RESPONSE TO COUNCIL INFORMATION REQUEST IN RELATION TO THE REEF MARINA REDEVELOPMENT – COMBINED APPLICATION

The following response is provided to Council's Information Request (IR) issued by correspondence dated 30 November, 2016.

APPENDIX: 1

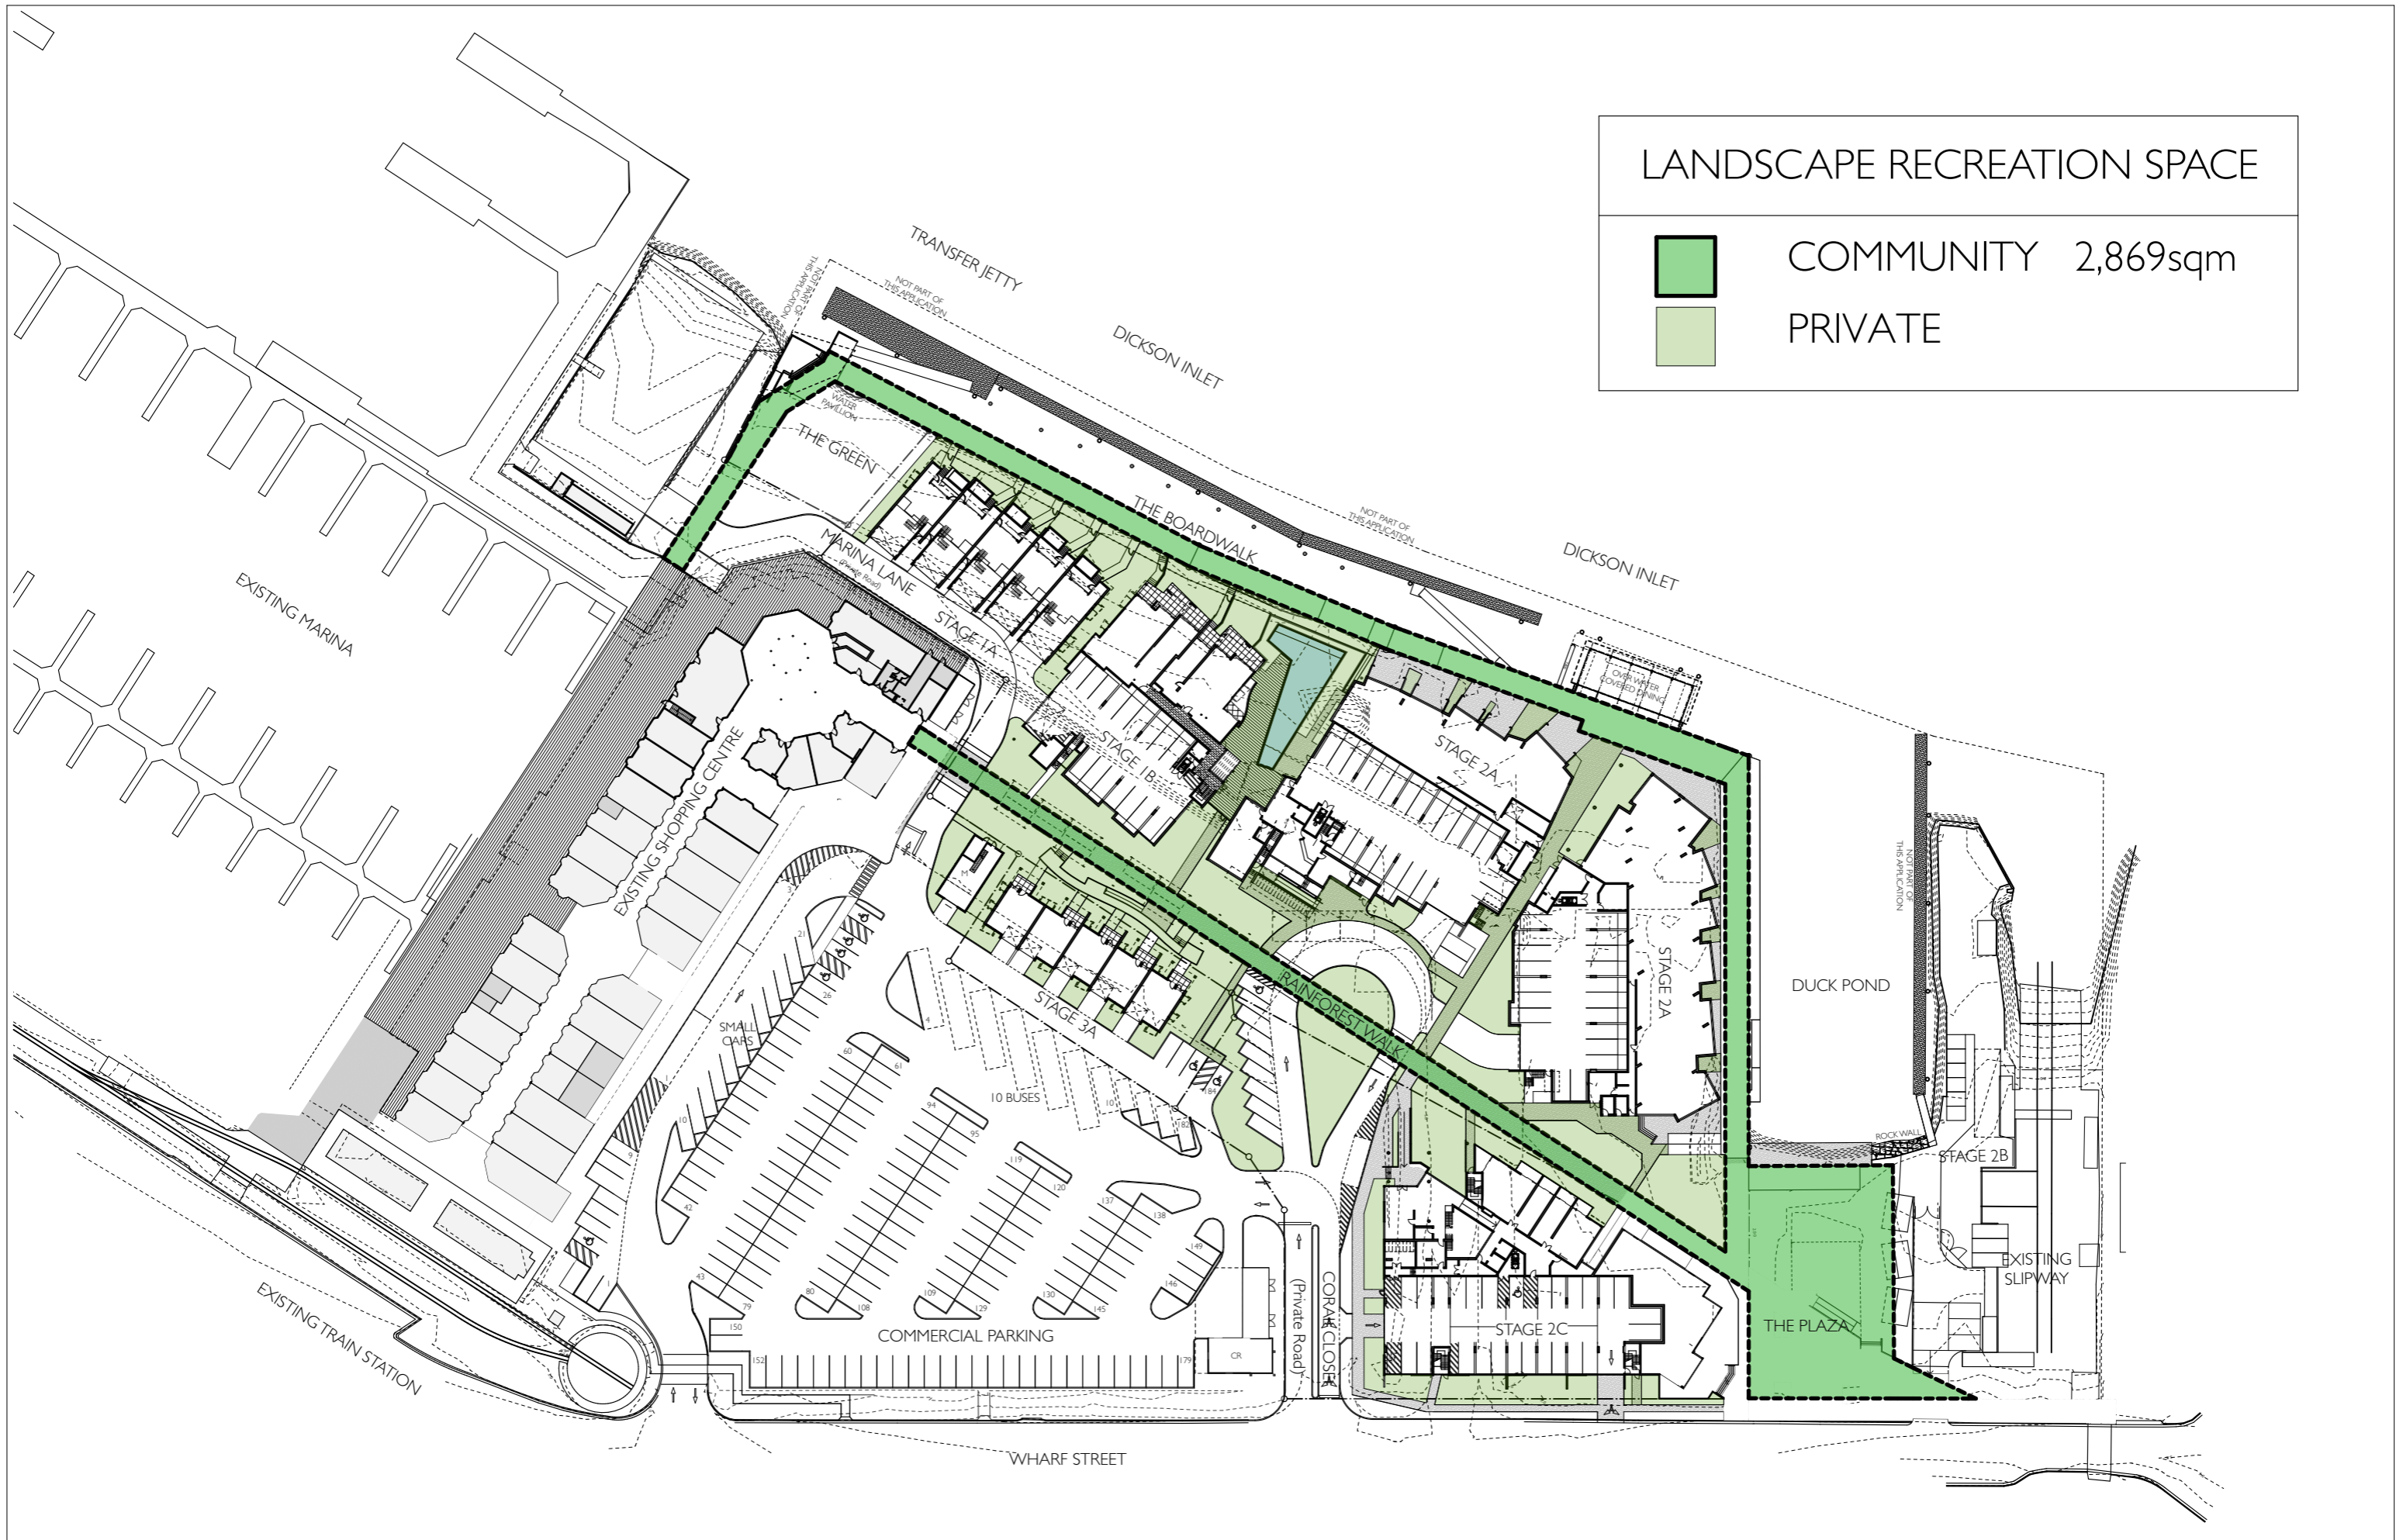
2. IDAS Form 7. 06. Table A indicates that the Boardwalk and The Rainforest are to be contributed for community purposes. Please clarify the intent of this statement and indicate the physical extent of this contribution in plan form.

The Boardwalk, the Rainforest Walk and the Public Plaza are public spaces that will be maintained at no cost to Council and integrated throughout the site through a Body Corporate arrangement.

These public space elements will not be “handed over” to Council as public land, but will be protected in perpetuity as public open space by Access Easements. The public benefit of this is that the maintenance of these spaces is not the responsibility of the public purse/rate payers.

A Plan showing the general extent of these public open space elements is attached at [Appendix 1](#).

SHOPPING CENTRE MODIFICATIONS

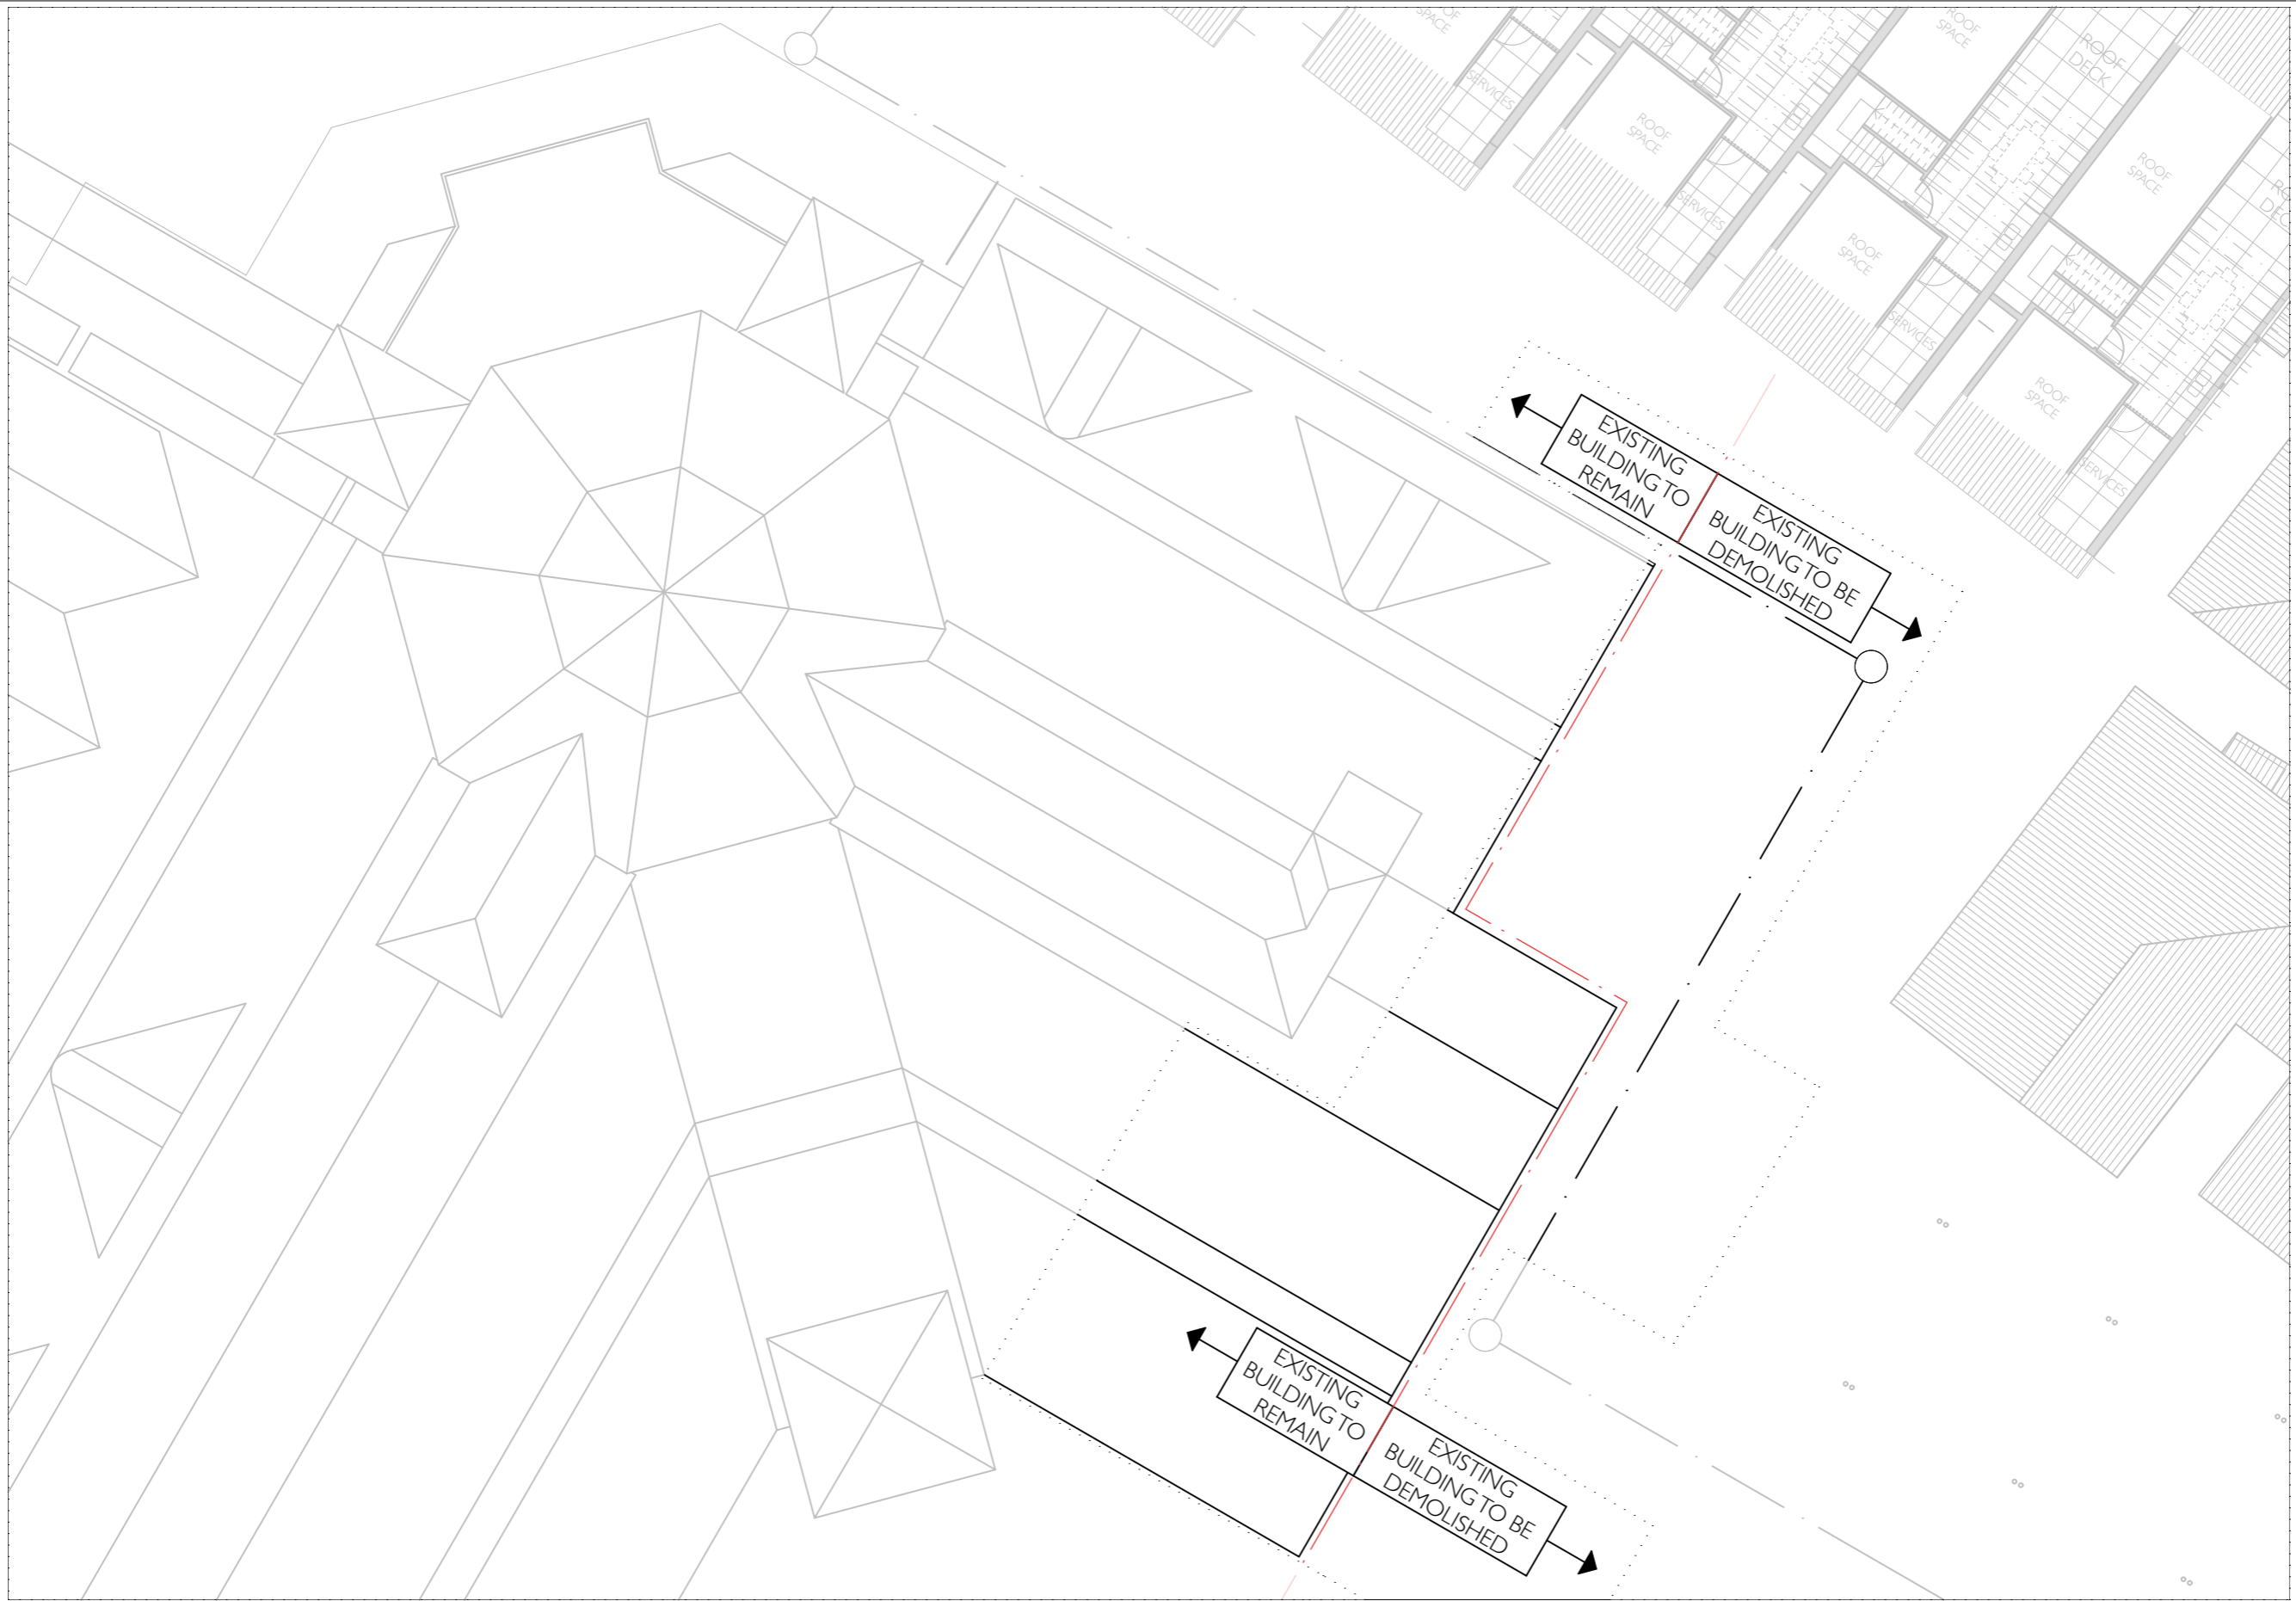
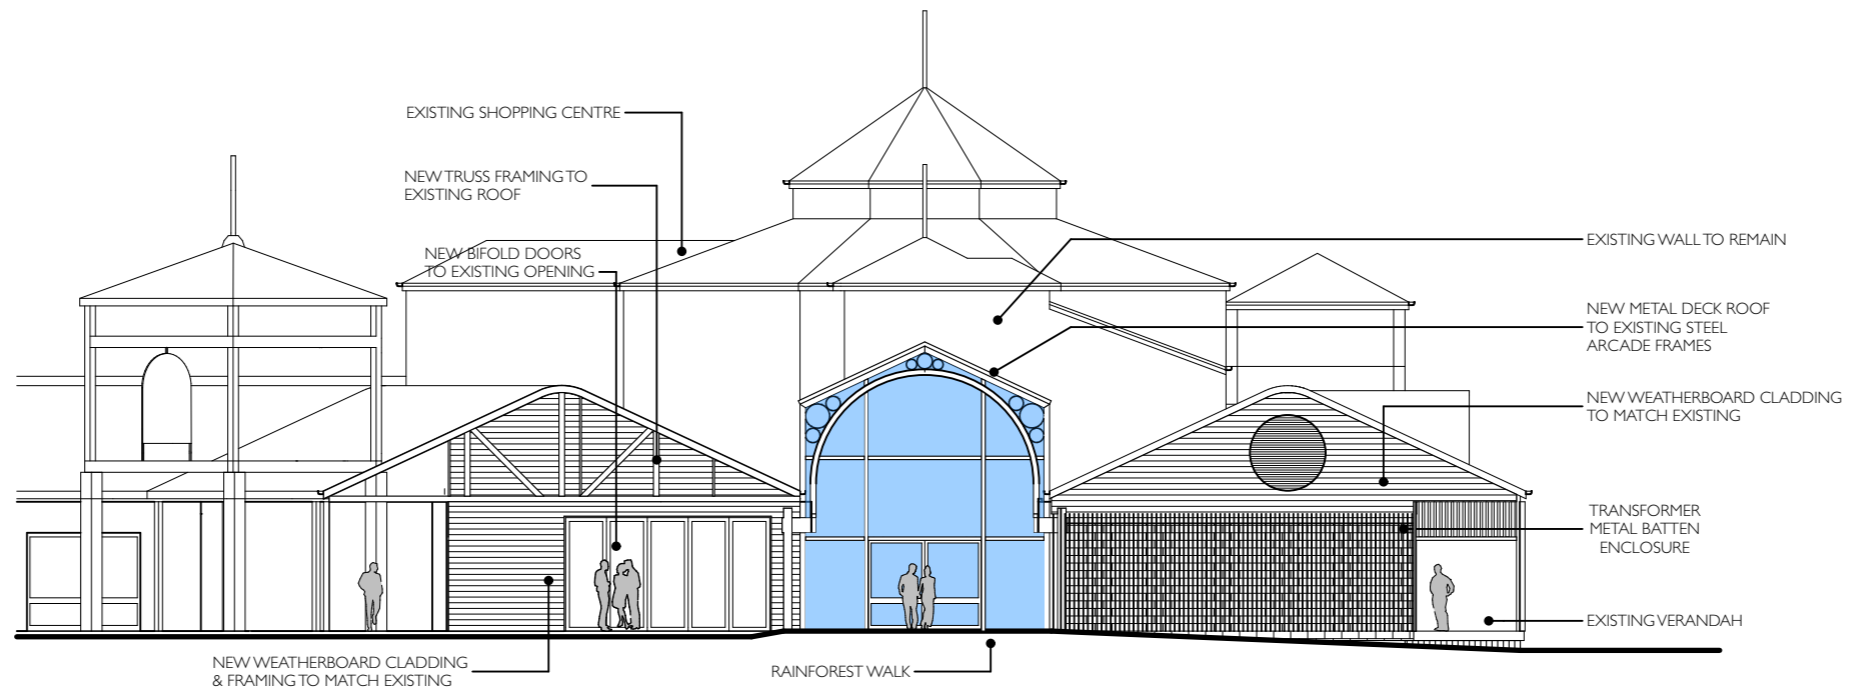
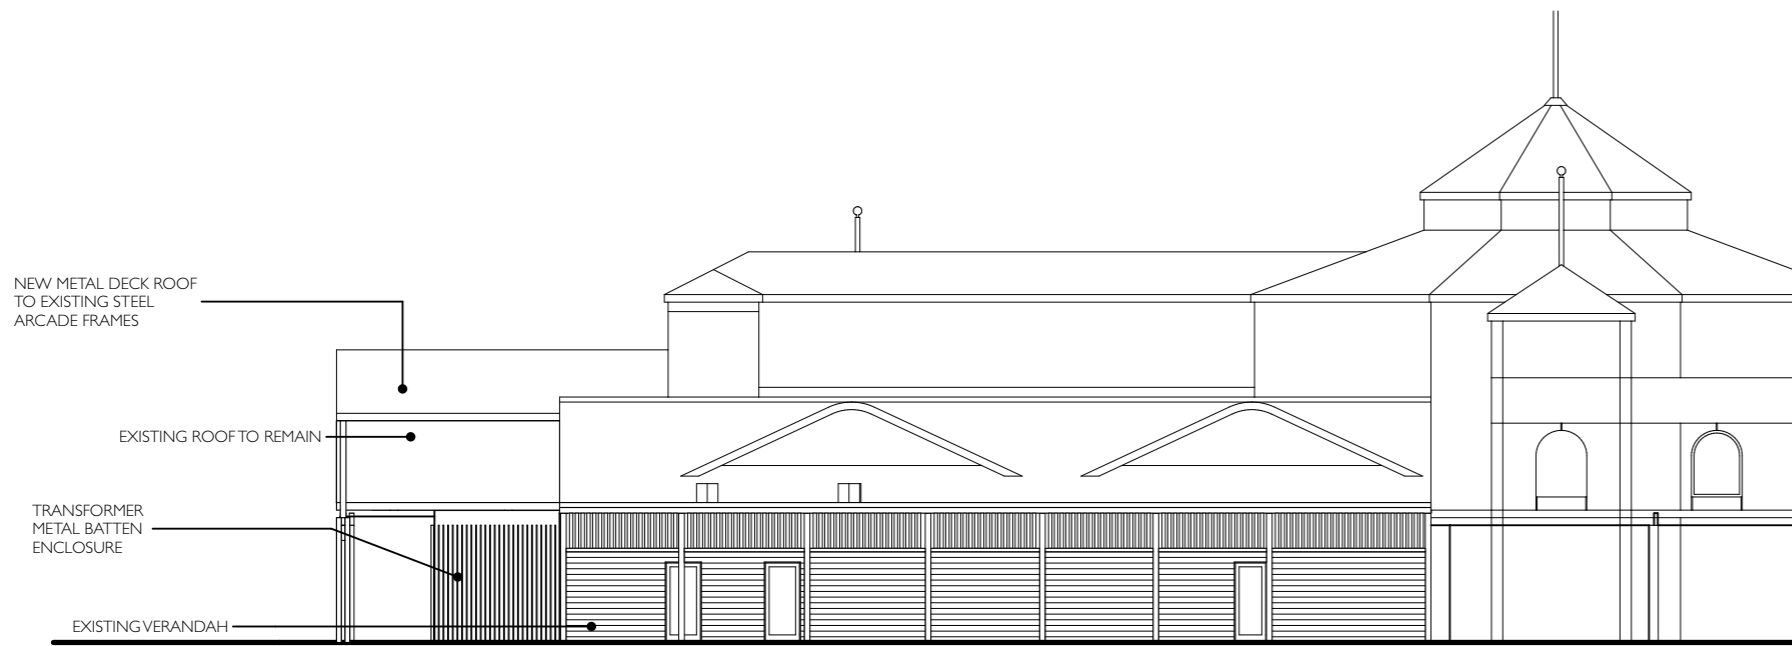
3. The application involves the demolition of a significant portion of existing commercial floor space at the Marina. Please provide elevations and floor plan details of the proposed modifications to the existing commercial building associated with this demolition.

The western wing of the existing Shopping Centre will be demolished up to the south west entry point and a new entry created linking with the Rainforest Walk, as indicated on drawings DA-IR-103, DA-IR-104 and DA-IR105- SHOPPING CENTRE MODIFICATIONS, refer [Appendix 2](#).

It is intended to reuse the existing steel mall columns and arches as a trellis structure for the Rainforest Walk with the addition of batten screens and the retention of some roofing sections to provide shade.
